Temporary Design Change

eAPB2133 | October 20, 2021

Temporary Design Change—Furnace Motor Arms

Composite Vortica Example

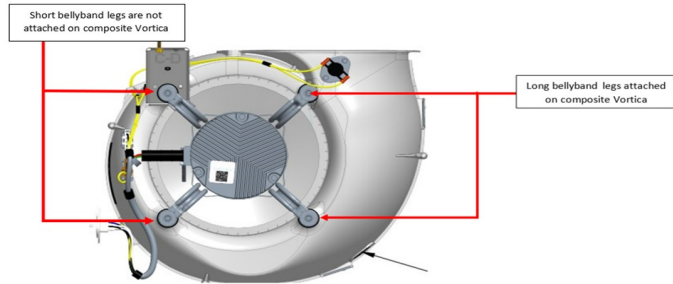
As a temporary measure to help ensure supply continuity, motor arms found on the S-Series and Ameristar families listed below will be revised to not include tabs that hold the arms in place as the motor belly band is removed. While we do not anticipate that this change will cause any issues or major disruptions, we wanted to share as much information as possible as servicing processes may slightly change.

On families containing composite, Vortica-style housings: shorter belly band legs will **not be attached** while longer belly band legs will be attached (families include S9V2-VS, S9V2, S9X2, S9X1, S9B1, A952V, A951X, L8V1*, L8X1* and P0V0*). Families containing metal, Vortica-style housings will have no attached belly band legs (families include S8X2, S8X1, S8B1, and A801X).

Composite Vortica units with a date code of approximately **21411** and metal Vortica units with a date code of approximately **21405** and forward will receive this change. A follow up announcement will be issued when the change has been reversed with an ending date code.
